Construction Division
Additions & Alteration Charges Approval Form

GULMOHAR RESIDENCY

Details of Additions & Alterations

Description	Direction	Owners & Developers :	Date :	Prepared By :	Prepared By :
		Modi Reality Mallapur LLP	16.09.20	Prepared By :	Modi Proprietor Pvt Ltd
PLUMBING PLAN-1360 Sfr (A2-TYPE)		Project Name & Phase :	Approved By :	Scale :	N.T.S
		Gulmohar Residency			Phone : +91-88-66333555

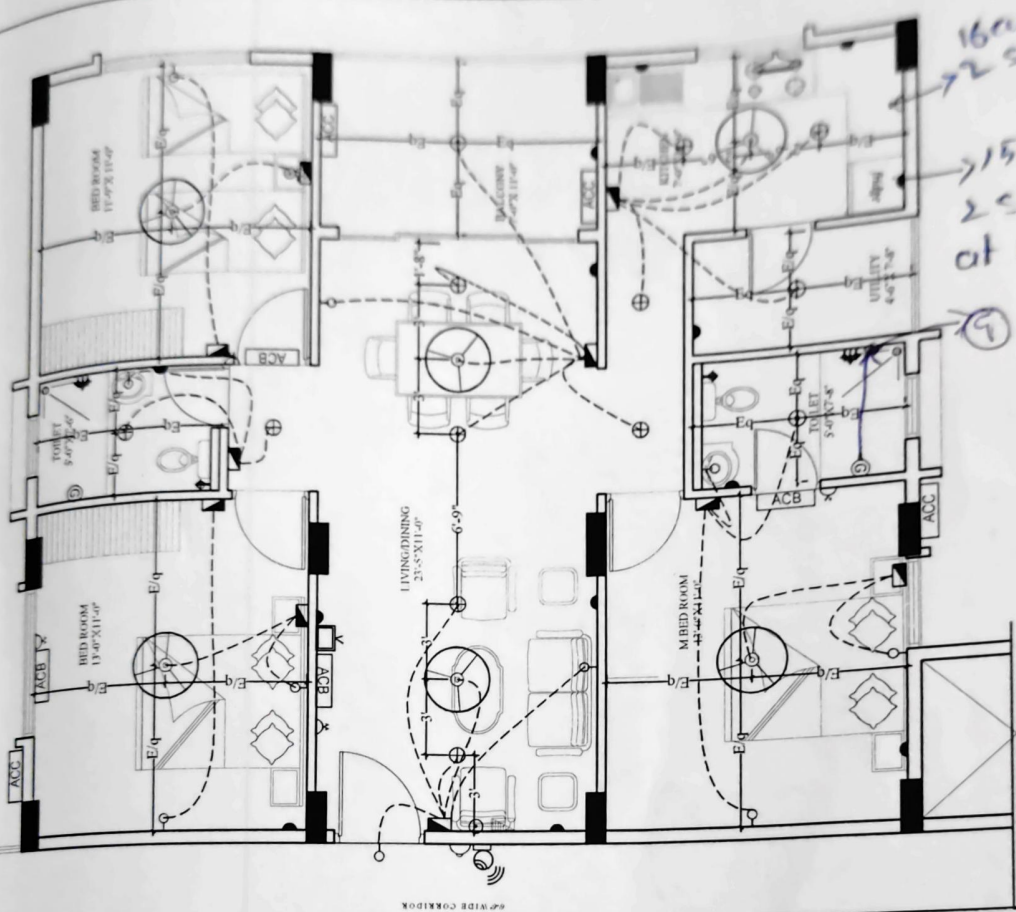
① Common Bath Room, W.C. point to North side wall,
wash Basin west side, wall mixed to east side center.

* Two Bathrooms ultra sprinkle as per
model flat & common Toilet East side
wall.

Remove the ledge wall for wash basin
